DESIGN REVIEW/CERTIFICATE OF APPROPRIATENESS APPLICATION

PROPERTY INFORMATION			
Project/Property Address: 788 Taylor Station Road		Project Name/Business Name: Speed Way Towing	
Parcel #: 025 003996/003942/003959/003961	Zoning: (see Map)	<input type="text" value="OCT"/>	Acreage: 4.152

Zoning File No. <u>DR-0090-2023</u>

RE: 788 TAYLOR STATION ROAD DESIGN REVIEW

1 DECIDUOUS TREE PLANTING
 NTS DETAIL-FILE

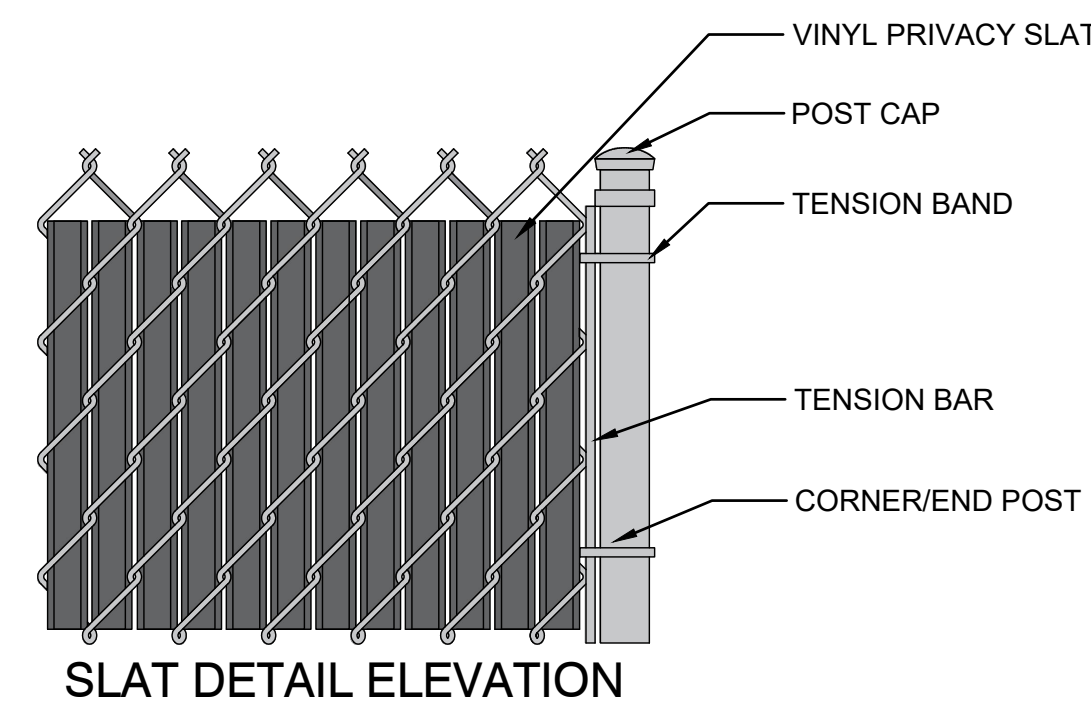
16. Street Tree Plans must be submitted to the Landscape Board.
17. Deciduous tree planting details should be updated
 - Pruning should only occur at time of planting if branches are broken or damaged
 - Root flare should be even with finished grade, root ball should not intentionally be planted high
 - 3" mulch should be pulled away from trunk to expose root flare

- 12. Deciduous tree planting details should be updated
 - Pruning should only occur at time of planting if branches are broken or damaged
 - Root flare should be even with finished grade, root ball should not intentionally be planted high
 - 3" mulch should be pulled away from trunk to expose root flare
- 13. Sea Green Junipers are fine for screening, but they cannot be planted in the ROW. They will cause visibility issues for traffic.
- 14. Planting plans do not reflect all of my comments from the last submittal. Root flare should be even with finished grade, root ball should not intentionally be planted high. Notes are still conflicting.
- 15. Street tree plans still need to be submitted to Landscape Board. I see that my comment about this was noted in the response letter from April 10.

RESPONSE: All landscape items are addressed on the plan.

SITE PLAN AND PRELIMINARY LANDSCAPE

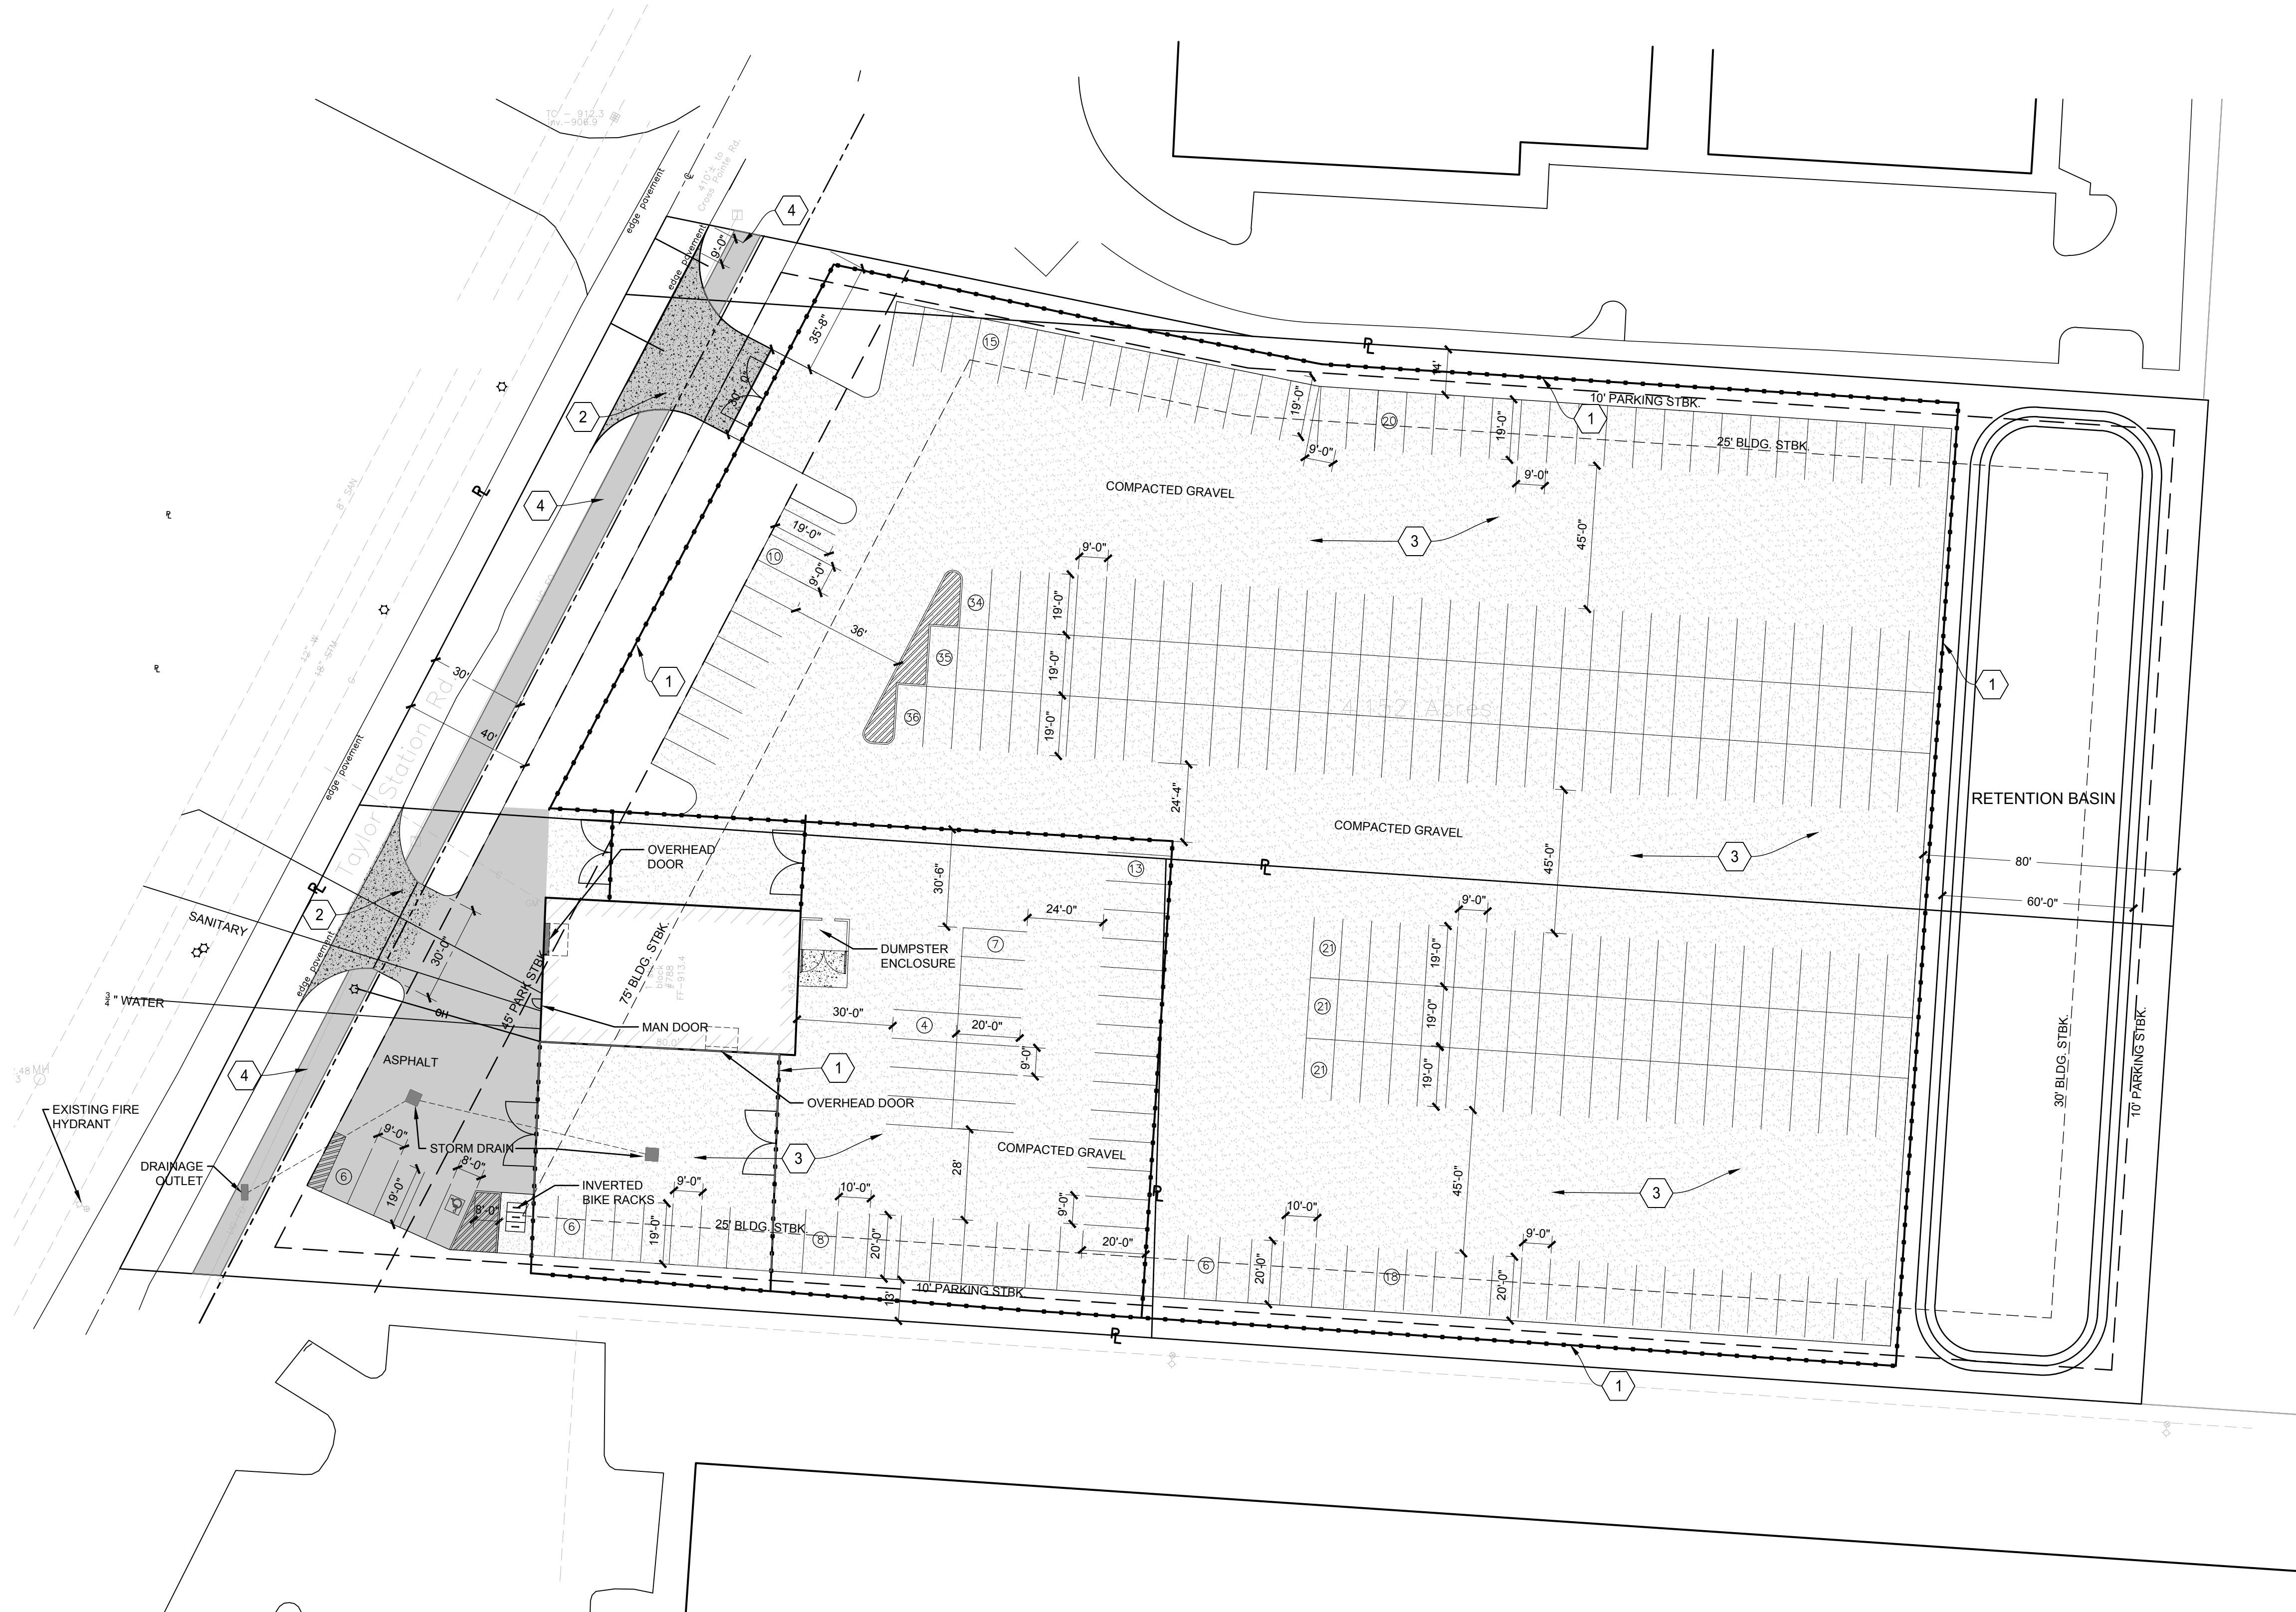
7. With the 40 foot right of way (from the centerline of Taylor Station Road), the site plan illustrates private improvements within the right of way. Additionally review and abide by any setbacks from the right of way.

14. Per Gahanna's 2019 Thoroughfare Plan, a right of way width of 80 feet is required along Taylor Station Road. Right-of-way dedication will be required along the property frontages to accommodate that need. Please revise the site plans to reflect that dedication.

1. Chapter 1155.04(c)(1)(A) – Parking setback
 - a. Code requires a 45’ setback along the right-of-way of Taylor Station Rd. The proposed setback distance isn’t depicted on the site plan or discussed in the variance application.

RESPONSE: Improvements have been removed from the Right of Way

RESPONSE: See revised plans.
